Lahore Water and Wastewater Management
Project (LWWMP)

Minutes of 1st Pre-Tender Meeting

**LAHORE WASTEWATER AND DRAINAGE MANAGEMENT
PROJECT (LWDMP) - SEWERAGE SYSTEM FROM LARECHS
COLONY TO GULSHAN E RAVI, LAHORE (THROUGH
TRENCHLESS TECHNOLOGY)**

**LAHORE WASTEWATER AND DRAINAGE MANAGEMENT PROJECT (LWDMP) –
SEWERAGE SYSTEM FROM LARECHS COLONY TO GULSHAN-E-RAVI LAHORE
MINUTES OF 1st PRE-TENDER MEETING HELD ON 30/10/2025 AT 1500 HRS
IN COMMITTEE ROOM, WASA HEAD OFFICE**

Annexure-H

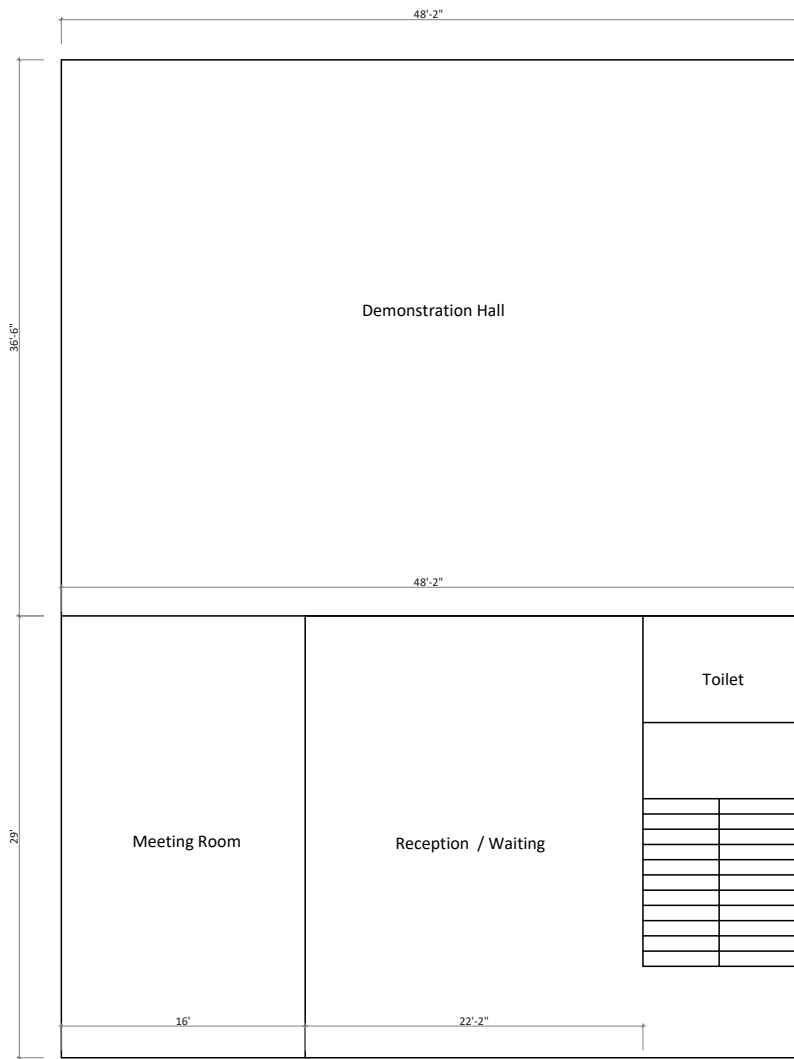
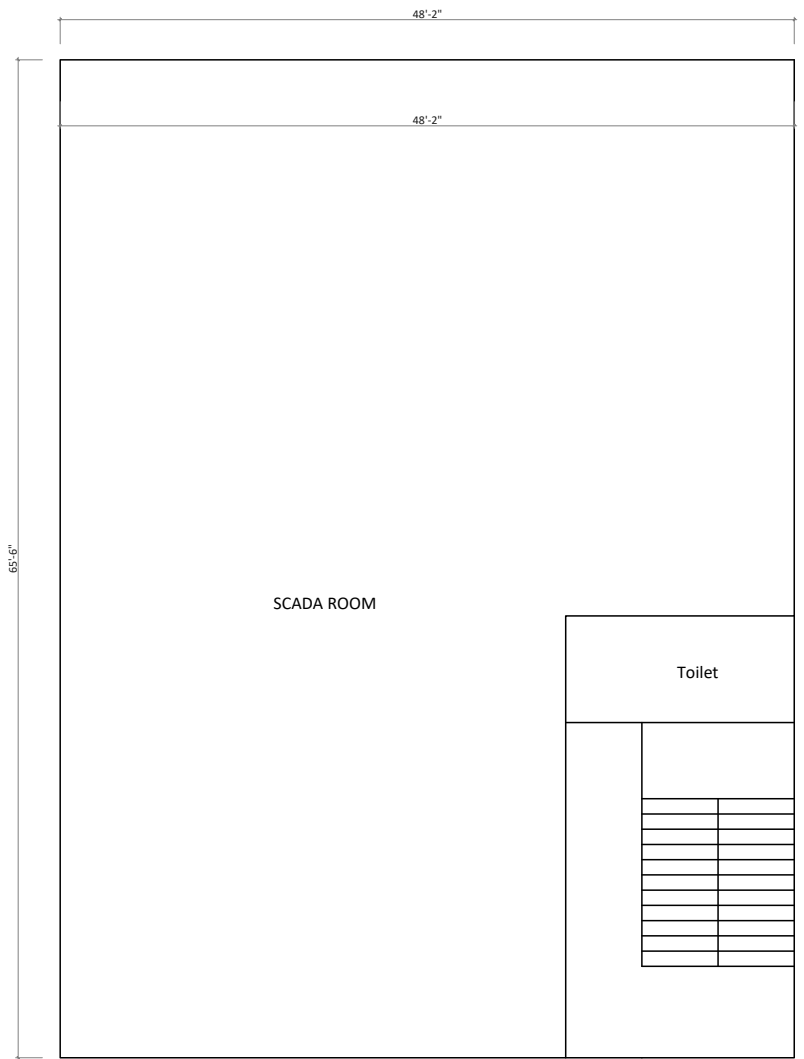
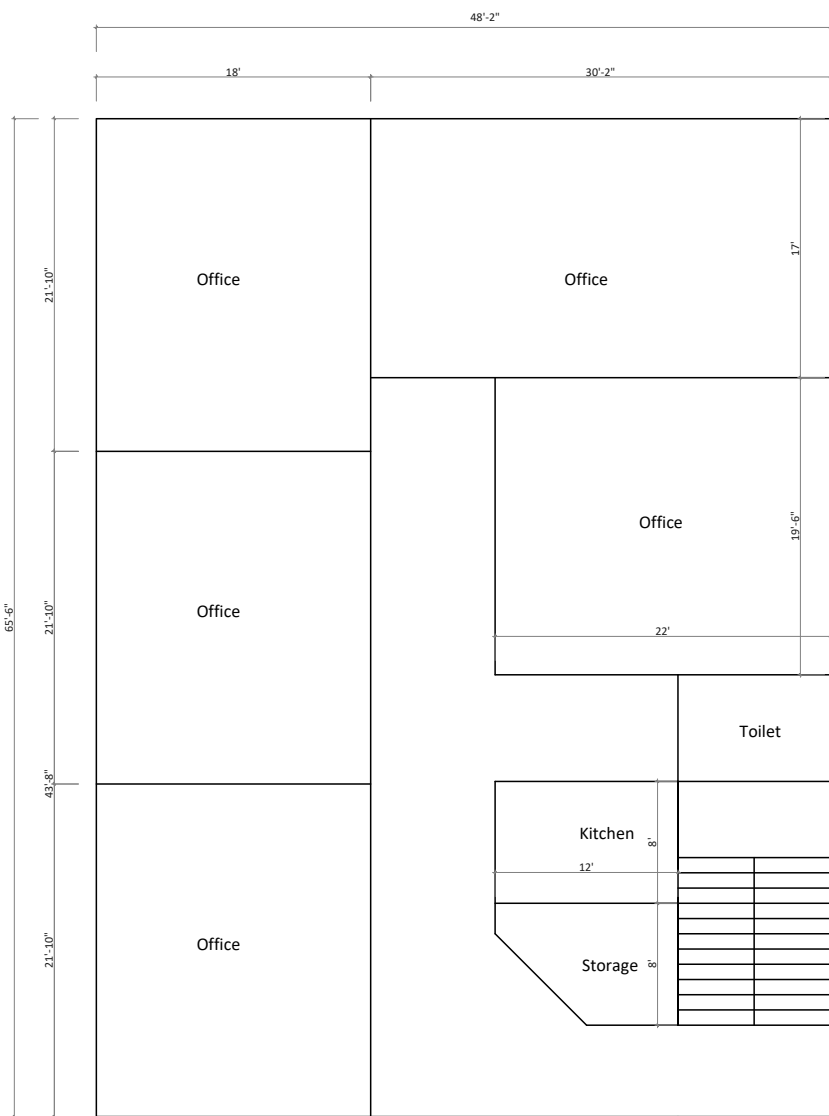
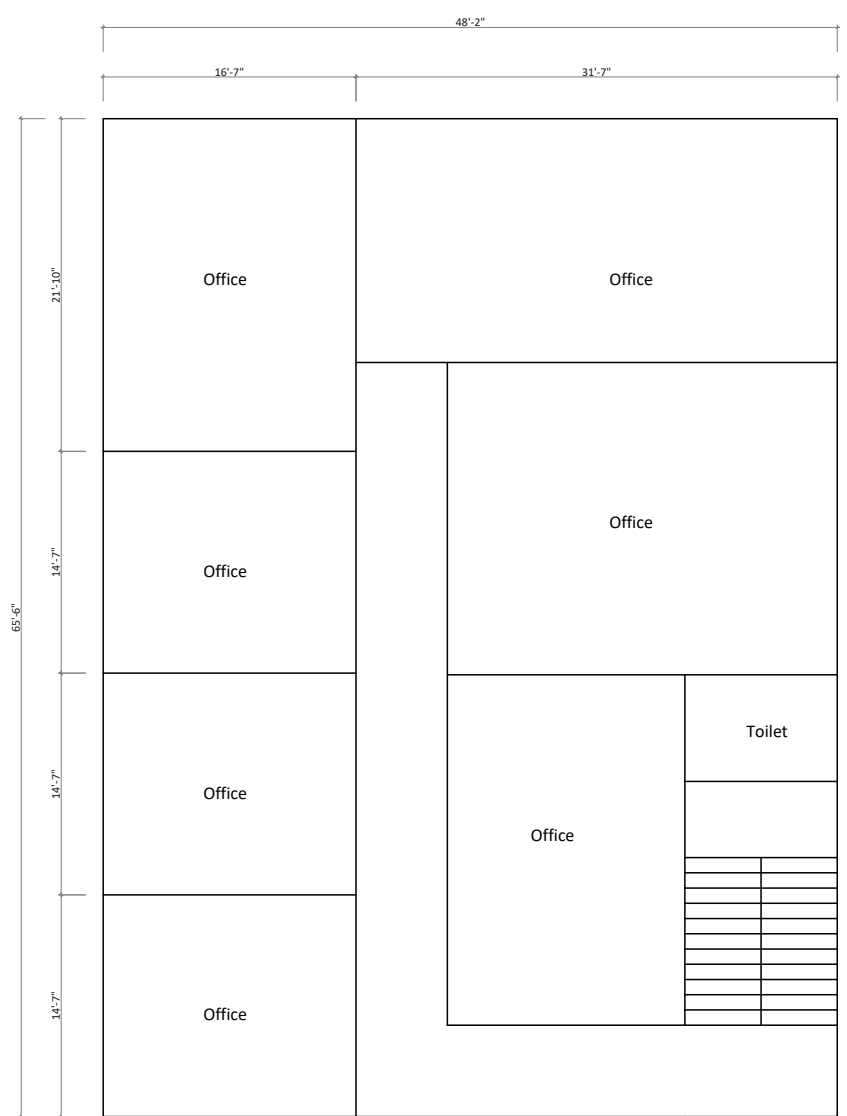
| Sr # | Reference Section | Queries | Employer's Response |
|------|--|---|---|
| 44. | Volume 2, Part II, Section 6 Employer Requirements Clause 4.1.11, subclause xx (page 6-67) | Construction of office Building It is mentioned that contractor must construct a fully functional three-story building other than ground floor (500 sq.m. per floor). However, in price schedule (item no. 3.27). It is only mentioned as a three-story office building. Please clarify, is it ground plus three story building or only 3 floors each of 500 sq.m. area? | It is to clarify that the Contractor shall construct a fully furnished ground plus three storey office building (total four storeys) with covered area of 296 sq-m of each floor with elevator. The layout of the building is given in Drawing attached as Annexure-H . An addendum will be issued reflecting the above. |

| | 04 | | | DRAWN | ARS | ULTIMATE DISPOSAL STATION SINGLE LINE DIAGRAM (SLD) | DATE:- NOVEMBER, 2025 | DRAWING NO.:- LW - TD - 491 |

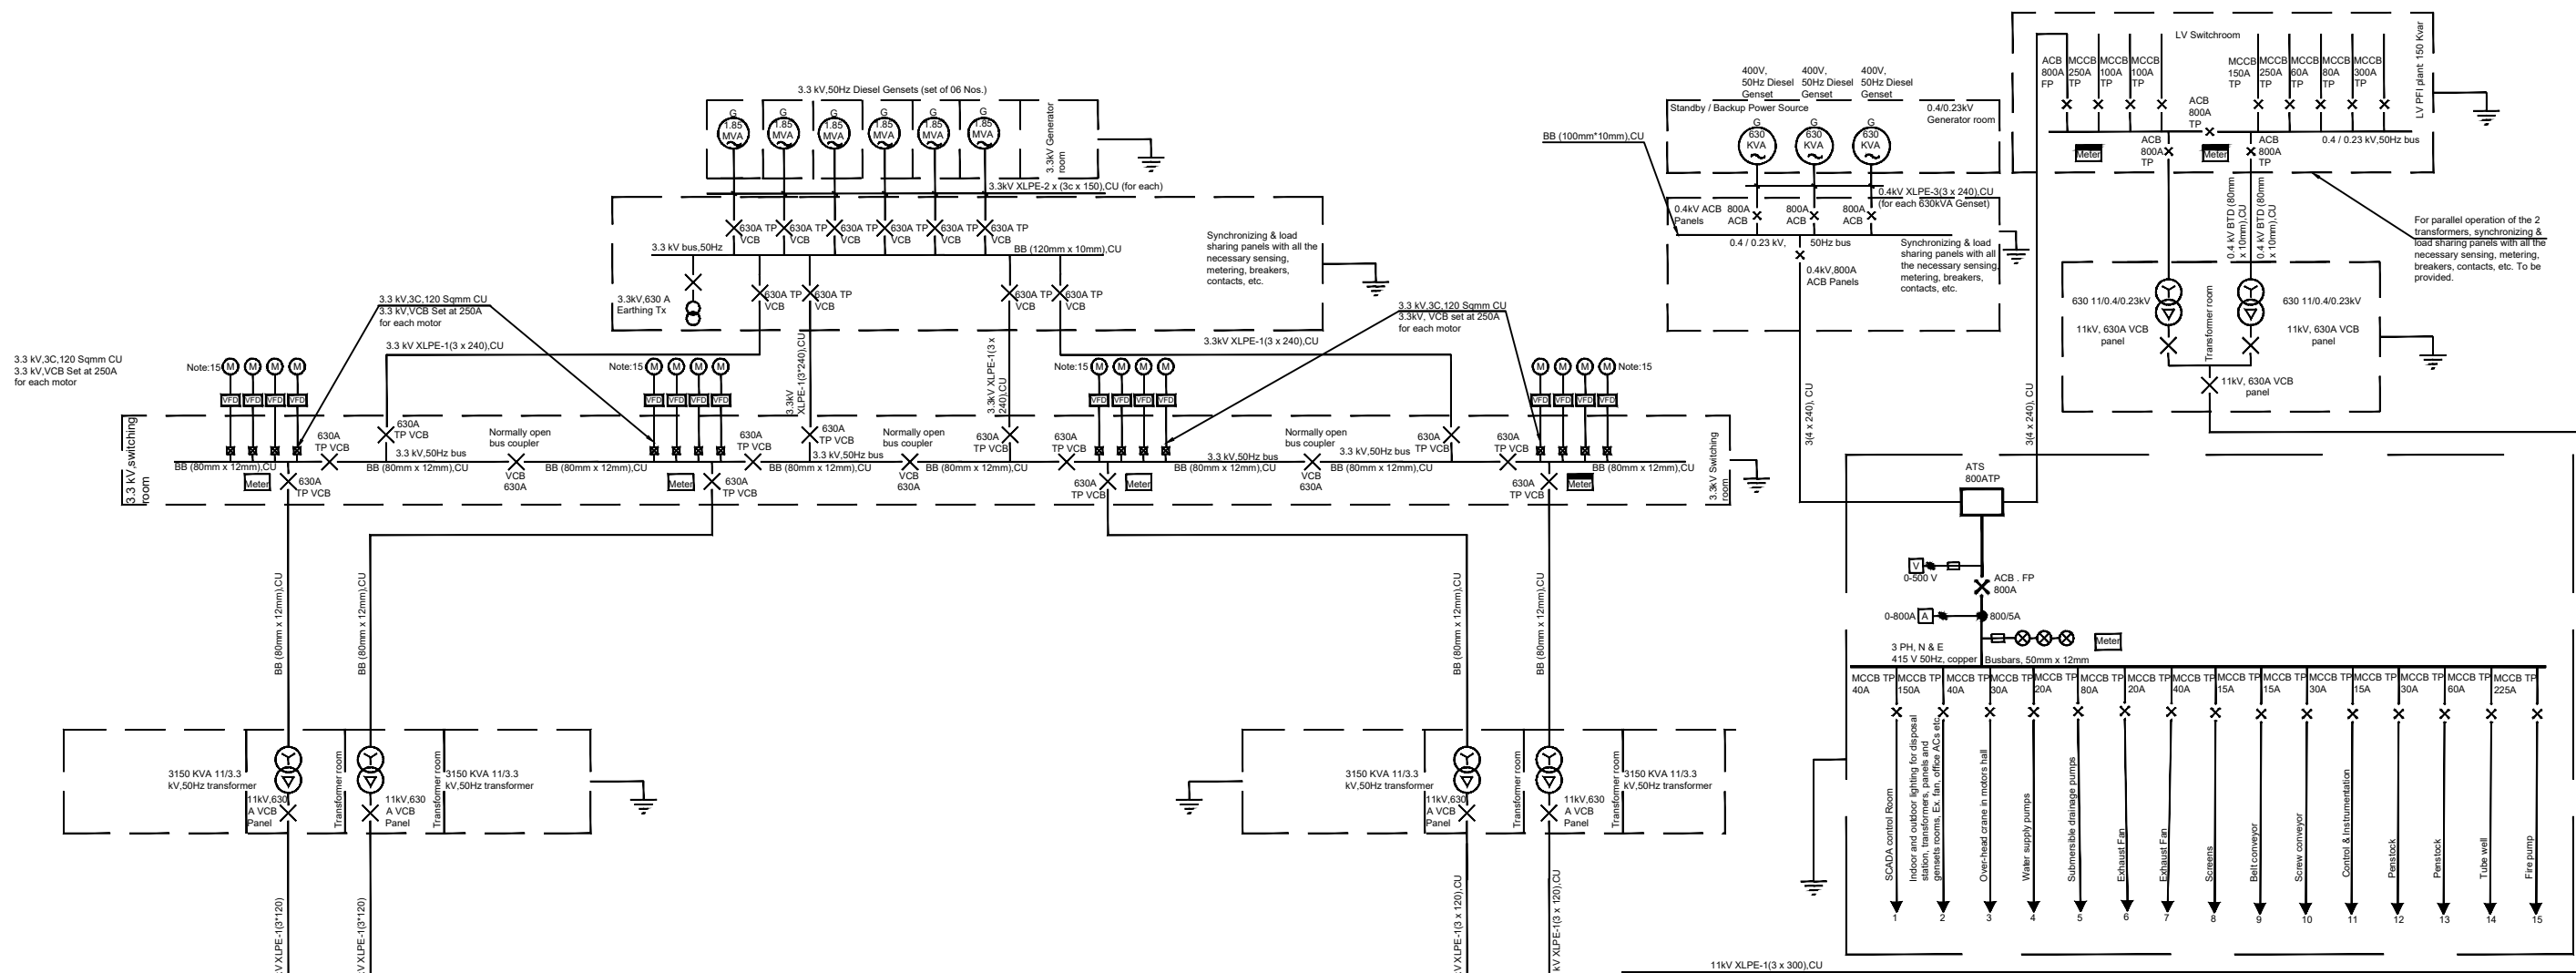
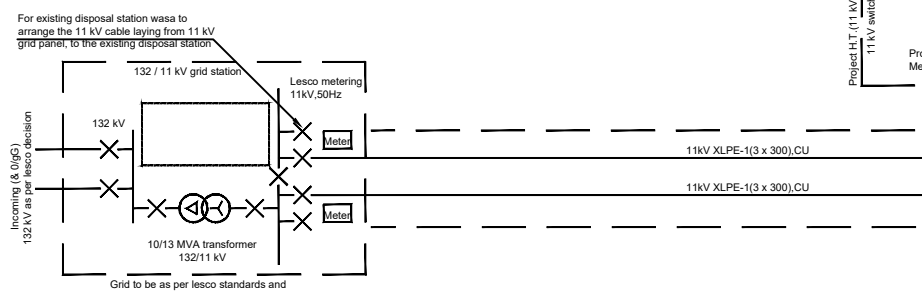
| Sr # | Reference Section | Queries | Employer's Response | | | | | | | | | | |
|------|---|---|--|--|---|--|--|---|---|--|---|---|--|
| 61. | <p>Volume-3, Part II, Section 6 - Employer Requirements, Technical specifications and detailed electrical configurations. Page 6-78.</p> <p>Volume-3, Part II, Section 6 - Employer Requirements, Tender Drawings.. Single Line Diagram (Drawing No. LW-TD-491)</p> | <table border="1" data-bbox="618 177 1305 451"> <tr> <td data-bbox="618 177 651 451">3</td> <td data-bbox="651 177 786 451">Consumer Metering and Protection Panel</td> <td data-bbox="786 177 943 451">As per WAPDA/LESCO</td> <td data-bbox="943 177 1066 451">WAPDA / NTDC IEC publication 56, 51, 185,85, B.S.88/1967, WAPDA standard specification P-44:2018</td> <td data-bbox="1066 177 1223 451">11kV-VCB Consumer Panel protection and metering, as per WAPDA/NTDC specification i.e. P-44.2018.</td> <td data-bbox="1223 177 1305 451">2</td> </tr> </table>  <p data-bbox="607 675 1317 1042"> 1) It is the Bidder's understanding that the Consumer Metering and Protection Panels correspond to the two (02) Incomer Panels indicated in the Single Line Diagram (Tender Drawing No. LW-TD-491) for the MV/11 kV Switchgear. Kindly confirm. 2) The Outgoing MV/11 kV Panels (05 Nos.), as shown in the Single Line Diagram (Tender Drawing No. LW-TD-491), are not referenced or described in the relevant Technical Specifications or detailed electrical configuration. Please clarify. </p> | 3 | Consumer Metering and Protection Panel | As per WAPDA/LESCO | WAPDA / NTDC IEC publication 56, 51, 185,85, B.S.88/1967, WAPDA standard specification P-44:2018 | 11kV-VCB Consumer Panel protection and metering, as per WAPDA/NTDC specification i.e. P-44.2018. | 2 | <p>1) It is to clarify that the Consumer Metering and Protection Panels correspond to the two (02) incomer panels indicated in the MV/11 kV switchgear on Tender Drawing No. LW-TD-491.</p> <p>2) It is to clarify that the five (05) outgoing MV/11 kV panels indicated in Tender Drawing No. LW-TD-491 are covered under the MV switchgear technical specifications already provided in the Tender Documents. The Bidder is referred to Section 6 – Employer's Requirements, Page 6-246, and our response at Serial No. 53 regarding MV type-testing and IEC 62271-200 compliance requirements.</p> | | | | |

| | | | | | | <p>DATE:- NOVEMBER, 2025</p> <p>DRAWING NO.:- LW - TD - 492</p> |

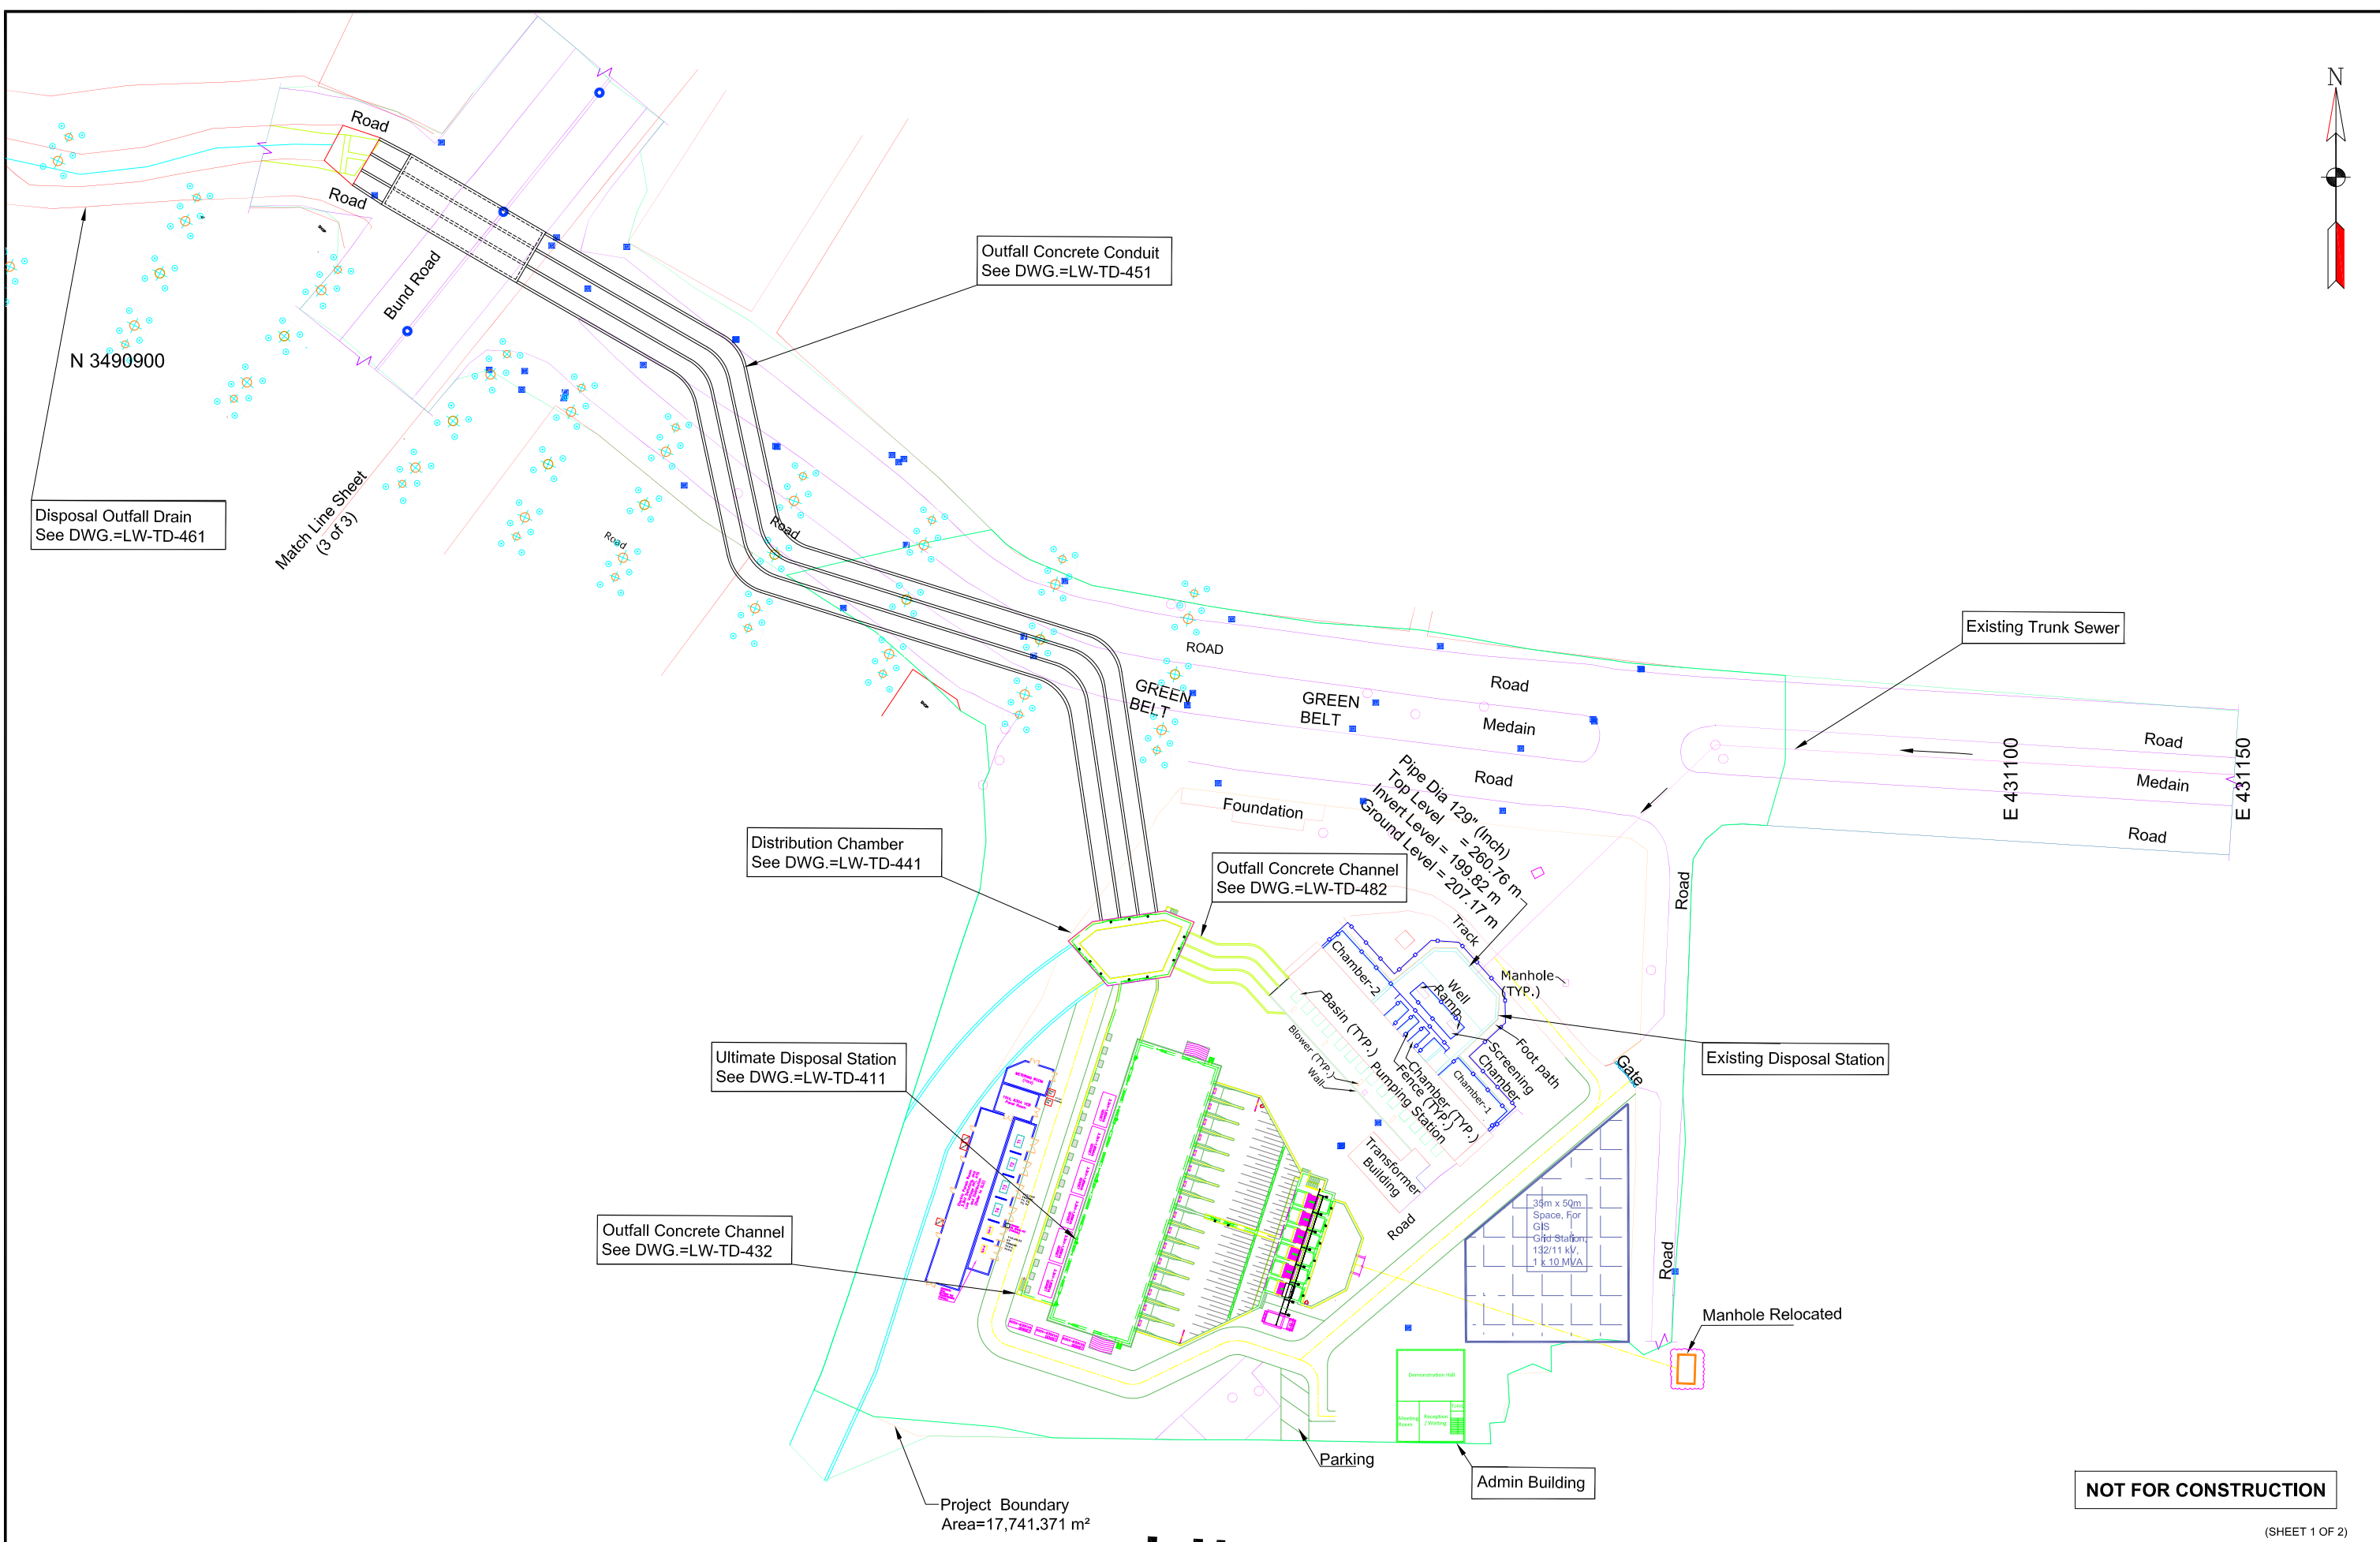
| Sr # | Reference Section | Queries | Employer's Response |
|------|--|---|--|
| 70. | <p>Volume-3, Part II, Section 6 - Employer Requirements, Tender Drawings.</p> <p>Master Layout Plan Pump House (Drawing No. LW-TD-402)</p> <p>Volume-3, Part II, Section</p> | <p>While reviewing both drawings in conjunction, it has been observed that the Admin Building and access roads are overlapping with the electrical buildings / installations.</p> <p>It is the Bidder's understanding that the provision of adequate space for the buildings, equipment, and other infrastructure works included in the Contractor's scope of work shall be the Client's responsibility. Please confirm.</p> | <p>It is to clarify that the updated switchgear and allied electrical installations, including the 132/11 kV grid area, transformers, panels, and trench layout, can be accommodated adjacent to and outside the pump house, as shown in the updated drawings (Drawing Nos. 492 and 493) annexed at Annexure-J.</p> <p>Furthermore, the control room, along with all associated accessories, shall be located on a dedicated floor within the administration/office building.</p> |

| Sr # | Reference Section | Queries | Employer's Response |
|------|--|--|---|
| | 6 - Employer Requirements, Tender Drawings.. 132/11kV Grid Space & Transformers, Panels, Trench Layout (Drawing No. LW-TD-492) | | Adequate space for all required buildings, equipment, and associated infrastructure has already been allocated within the existing Gulshan-e-Ravi Pumping Station premises and is reflected in the tender drawings. No additional land or space allocation shall be provided. |
